SUBMITTAL TO THE BOARD OF SUPERVISORS
COUNTY OF RIVERSIDE, STATE OF CALIFORNIA

SUBJECT: FACILITIES MANAGEMENT AND RIVERSIDE UNIVERSITY HEALTH SYSTEM: Riverside University Health System Medical Center Labor & Delivery Room, Neonatal Intensive Care Unit, and Pediatrics Accessibility and Reconfiguration Project - Approval of Revised Project Budget, Approval of Change Order No. 1 for Vincor Construction, Inc., and Approval of First Amended and Restated Professional Services Agreement with Westgroup Designs, Inc.; District 5. [\$571,428 - 100% RUHS Enterprise Fund 40050](4/5 Vote Required)

CHANGE ORDER NO. 1

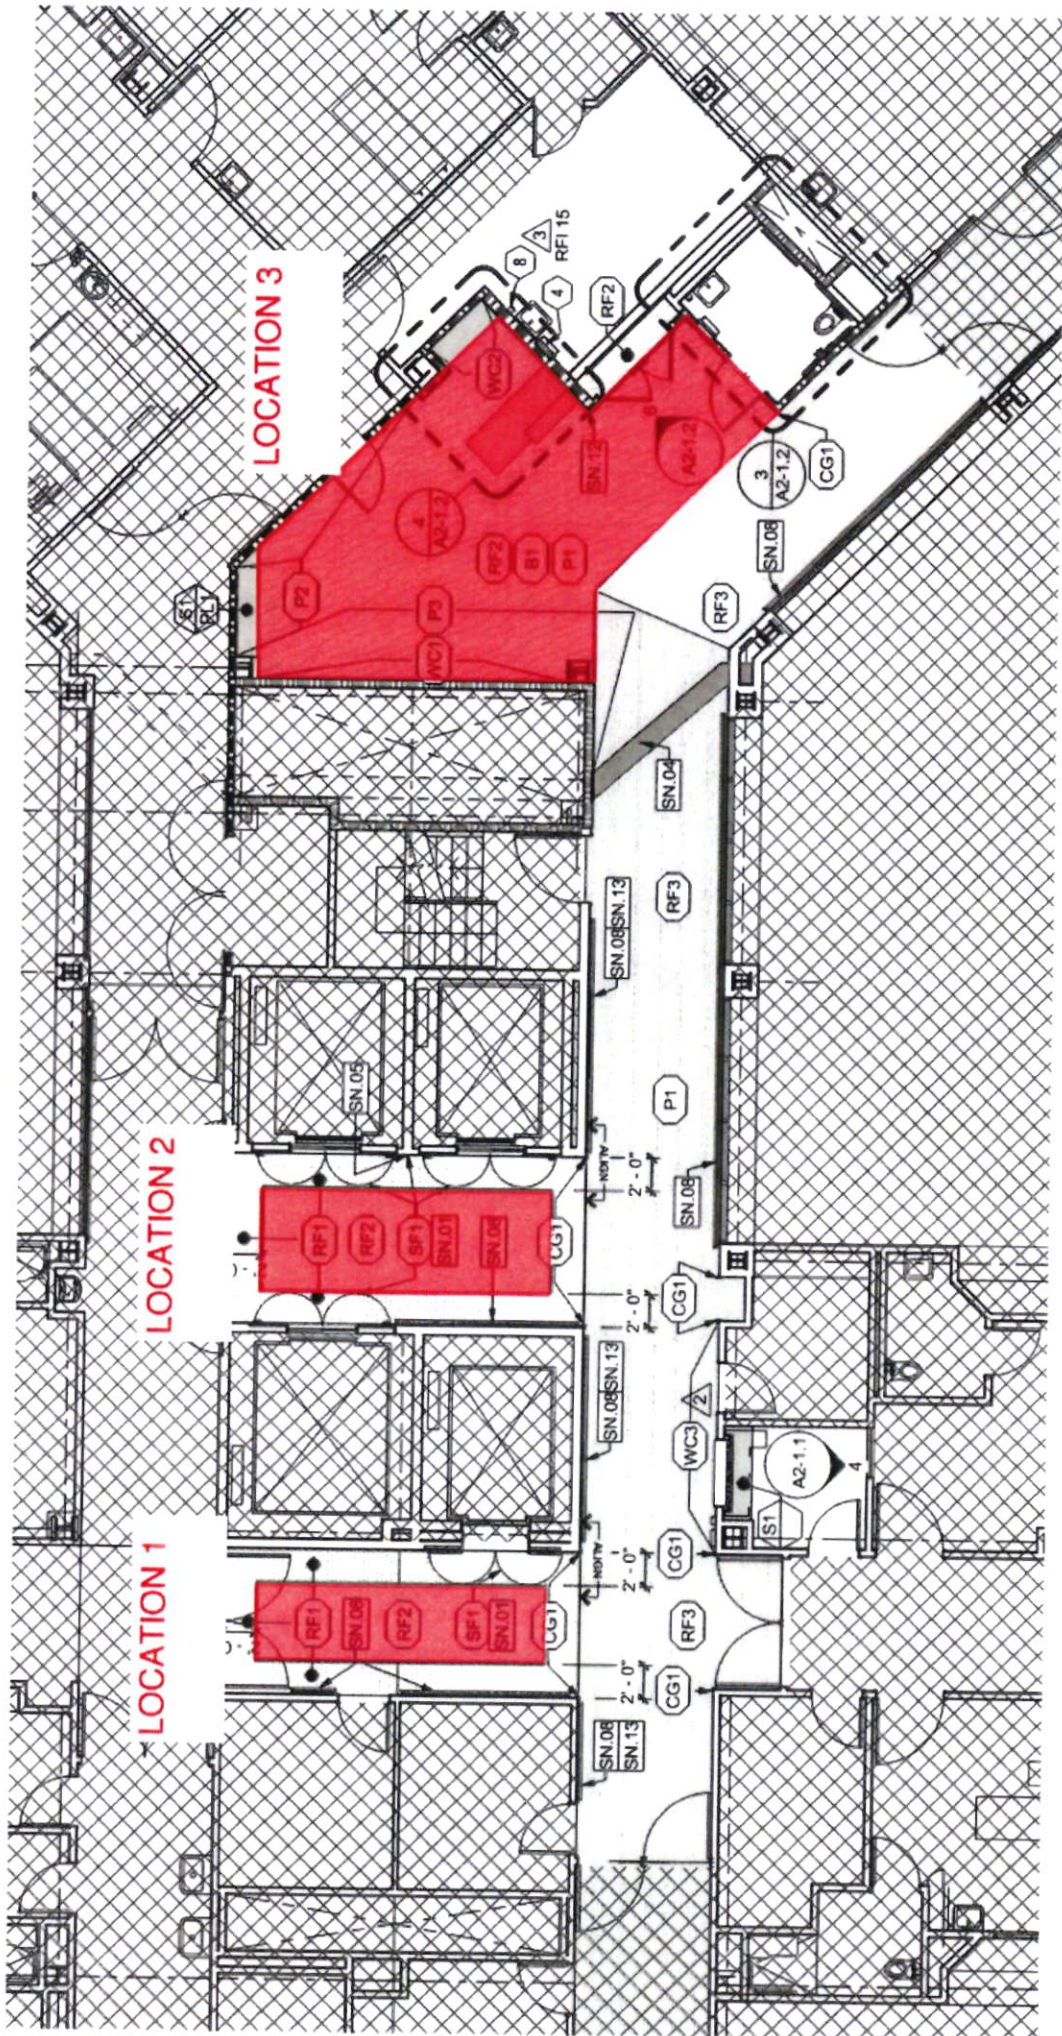
Question **Question from Patrick Galvez Vincor Construction, Inc. on Wednesday, Apr 12, 2023 at 02:24 PM PDT**
 Hi Jon - There is an existing Jbox attached to the NICU wall that will get buried behind our rated wall/ceiling. Can you please provide direction? Are we to install an access panel ? Thank you
